4300408 – PIPE CULVERTS
COMMENTS FROM INDUSTRY REVIEW

(REV 12-7-07) (12-10-07) (1-08)
ARTICLE 430-2 (of the Supplemental Specifications) is deleted and the following substituted:

SIGNIFICANT CRACK

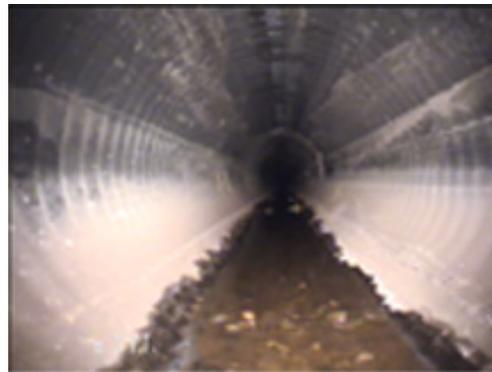
1. Actual recorded length and width measurements of all cracks within the pipe. Show calibration procedure on screen and recorded on the video for each measurement recorded. Evidence must be provided for each measurement that the camera lens and video micrometer is positioned perpendicular to the observation being measured. **We believe this is too general a statement with regard to crack measurement. Our survey experience has found that many new concrete pipes have a multitude of "spider" and other insignificant cracks. Published studies by the concrete pipe industry and universities, both nationally and internationally have stated that**

TYPICAL DRAIN LINE ENVIRONMENT

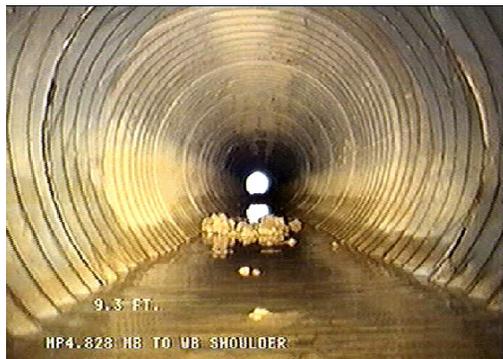
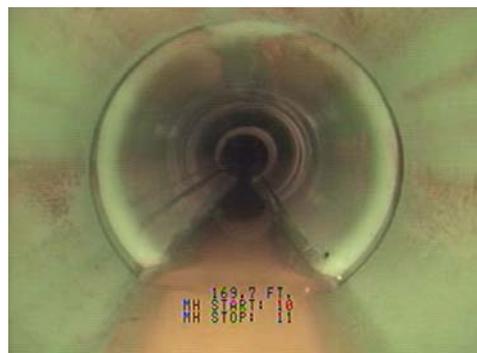
2. Actual recorded separation measurement of all pipe joints gaps. Record in the video and report the locations along the pipe joint four measurement locations separated by 90° beginning at the widest observed joint gap location on the pipe section. If the widest gap is at 3 – 9 or 12 o'clock it may be impossible to measure at the 6 o'clock position due to silt, flow or debris in the joint. We recommend the following “All joints shall be measured at their widest visible separation. If the joint gap exceeds the pipe manufactures specification it shall then be measured at three additional locations approximately 90° apart. The inspection report shall record all joints that exceed manufacturers specification with video still frames of all bad or damaged seals and/or external infiltration including their distance location within the pipe”.

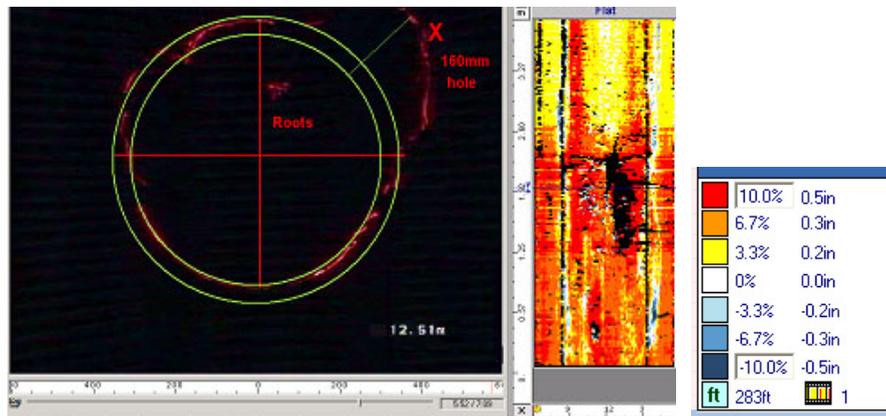
There are a number of formulas that have been used by the pipe industry to calculate ovality. For uniformity and accuracy of reporting, the formula (or formulas) should be included in the specification. The flexible pipe industry divides the horizontal axis by the vertical axis to establish percentage of deformation. This does not work when a pipe has a size change within a line. The ovality formula, recognized by the majority of pipe authorities, is the ovality formula as specified in ASTM 1216. This formula provides an accurate ovality percentage regardless of the

diameter of the pipe from entry to exit, and regardless of pipe type, or internal size change. The ASTM 1216 ovality formula is the most accepted and universally used standard throughout the world.

The ovality formulas to be used should be specified and the hardware and software then independently tested to an approved standard.

We suggest the following statement “Ovality measurement and graphical reports shall be calculated using the q-factor formula as specified in ASTM 1216, paragraph X1.2.1 or approved equal”

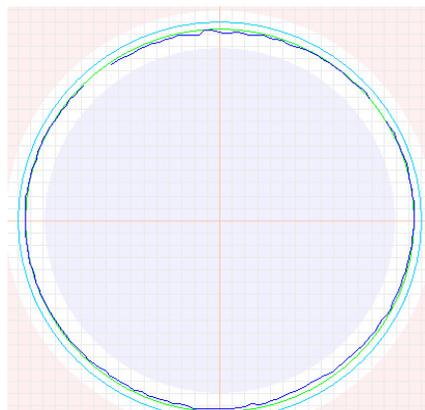
8. Deviation in pipe line and grade. Provide in the reporting a graphical representation from structure to structure of the actual line and grade maintained during installation. We believe this needs further clarification. There are many instruments from pipe laying lasers, to special 3 axis geophysical units, surveying equipment and inclinometers built into CCTV cameras available to measure line grade. The cost of the inspection instrumentation, time to inspect and the resulting cost of inspection will depend on the accuracy required by the specification. The

most inexpensive instrument would be an inclinometer built into a CCTV inspection camera system. Today CCTV inspection camera's inclination system accuracy is usually specified as $\pm 0.2^\circ$ and range of $\pm 5^\circ$.

Calibrator Recorded On Each Inspection Video

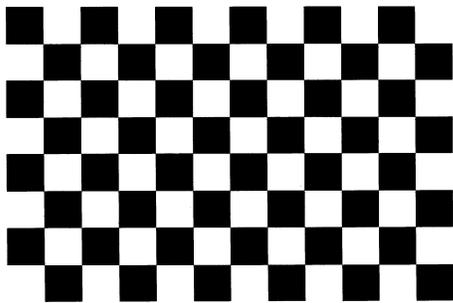
A major reason to have verification of calibration of each surveyed line is in a situation where legal action or large construction replacement expense may be involved. We believe the court will demand proof of calibration "**at the time of that inspection**". We do not believe an annual only certification, by an independent laboratory, will satisfy the Courts. We would recommend that a calibration calibrator be recorded and verified on each inspection video recording and profiling report.

BARREL DISTORTION TEST CHART

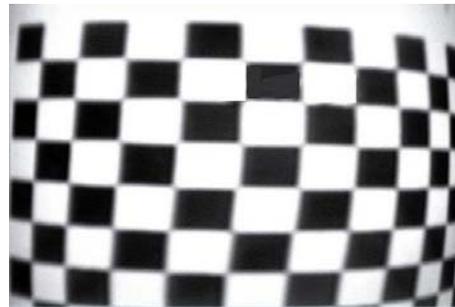
Another form, of potentially required software calibration, is called barrel distortion correction. All CCTV cameras have some barrel distortion. This needs to be corrected, in the processing software, if the data will be submitted to a court of law. We recommend that the specification state “The software processing shall include barrel distortion correction of the camera as used for the inspection, and fully state in the inspection report that barrel correction has been applied.
